TEKCAST 100D DOOR LATCH REPLACEMENT

Subject; Tekcast 100D Door Latch TZ01-127-R1

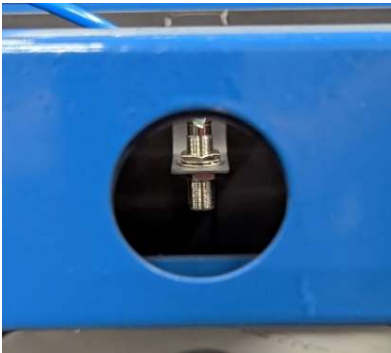
The original door latch was discontinued and up grade to a push button latch TZ01-127-93

DOOR HANDLE-RETRO-1-A7-10-301 HAS BEEN DISCONTINUED

#1 First punch a 1.250" HOLE in the cross beam 1.342 from the top.

#2 Then close the door and scribe a circle from the door hole.

#3 Install door catch if needed.
